Access Compliance Report

Public Rights-of-Way

(Curb Ramps)

Intersection ID: 20205	Main Street: FAIRVIEW_RD	Cross Street: OLD_SAYBROOK_CT	Location: W
ADA ID: F5C4CD130C0A	Ramp Type: PerpDiag	Initial Pass/Fail: Fail	Overall Compliance: No
Severity Score: 12.5			
Codes/Mitigation Info/Possible Solution		Field Measurements/Component Compliance

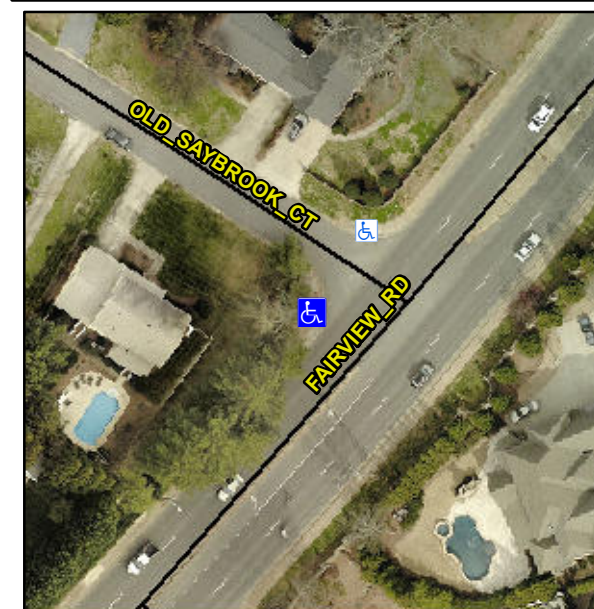
Not Found, R304.2.2

Compliance	Description	Data	Compliance	Description	Data
N/A	Ramp Length (in)	60.0	No	Ramp Slope (%)	10.0
Yes	Ramp Width (in)	48.0	Yes	Ramp XSlope (%)	1.4
N/A	Flare Type LT	N/A	N/A	Flare Type RT	N/A
N/A	Flare Slope LT (%)	N/A	N/A	Flare Slope RT (%)	N/A
N/A	Flare Traversable LT?	N/A	N/A	Flare Traversable RT?	N/A
N/A	Landing Length (in)	N/A	N/A	DWS Provided?	N/A
N/A	Landing Width (in)	N/A	N/A	DWS Contrast?	N/A
N/A	Landing Slope (%)	N/A	N/A	DWS Length (in)	N/A
N/A	Landing X Slope (%)	N/A	N/A	DWS Full Width?	N/A
N/A	Landing Curb? (Y/N)	N/A	N/A	DWS Offset (in)	N/A
N/A	Shared Landing?	N/A			
N/A	Gutter Ponding?	N/A	N/A	Gutter Slope (%)	N/A
N/A	Gutter Lip Ht (in)	N/A	N/A	Gutter X Slope (%)	N/A
N/A	Painted X Walk1?	No	N/A	Painted X Walk2?	No
	X Walk 1 Direction	To SE		X Walk 2 Direction	To NE
N/A	X Walk 1 Width (in)	N/A	N/A	X Walk 2 Width (in)	N/A
	X Walk 1 Slope (%)	0.1		X Walk 2 Slope (%)	3.3
	X Walk 1 X Slope (%)	2.4		X Walk 2 X Slope (%)	0.3

Remove & Replace Curb Ramp With Two New Directional Ramps or Equivalent.
